SUBJECT: San Diego State University Proposed Canyon Destruction

Responses to Comments – Individuals

Response to Comment Letter I1

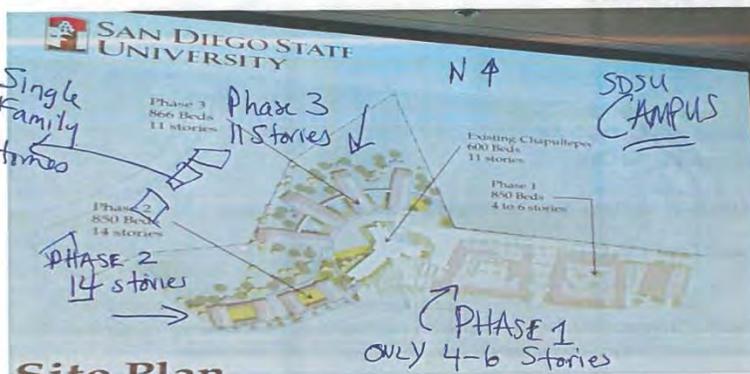
The map below from an SDSU presentation shows the 3 Phases of the project. Phase 1 is on disturbed land (a parking lot) toward the interior of the campus and is only 4-6 stories tall. It sits next to an 11 story existing dorm that is the tallest structure on the SDSU campus. Phases 2 and 3 are both proposed to be built by destroying the canyon and will be 11-14 stories tall, or

nearly 10-15 times the height of the single family properties at their adjoining lot lines to the west.

- I1-1** The comment refers to the project’s potential impacts to the canyon that would result with implementation of Phases II and III and requests consideration of a Phase I only project. Following submittal of the comment, and based on input received from public agencies and the community, the proposed project was modified to eliminate Phases II and III. Please see Final EIR, Preface, for additional information regarding the project modifications.

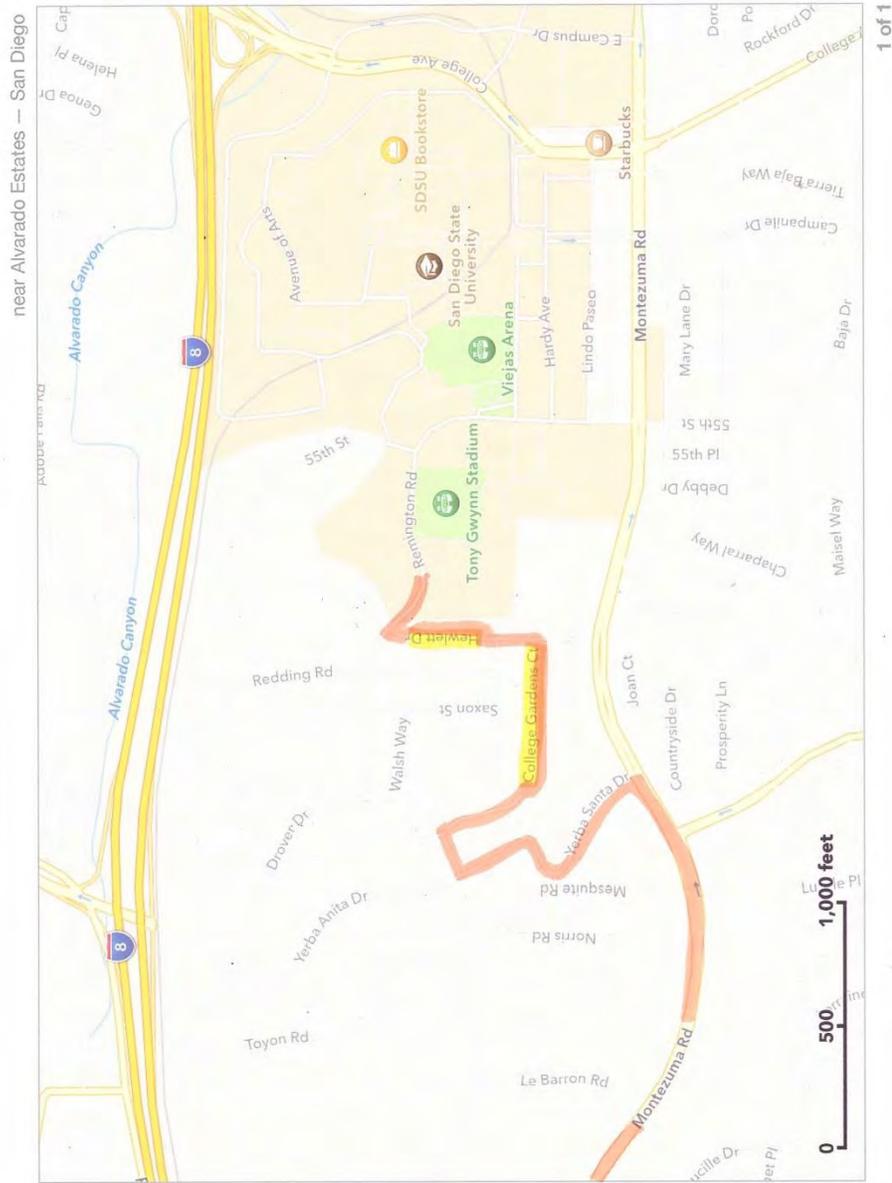
I16-9

I16-6 The comment refers to a map that the commentator claims supports the prior comments regarding the Project’s impacts on Hewlett Drive and College Gardens Court. However, the map only highlights the circuitous route from the Project site through the referenced neighborhood and does not rebut the findings of the EIR traffic analysis nor provide support for the claim that the Project would result in significant traffic impacts in the neighborhood.
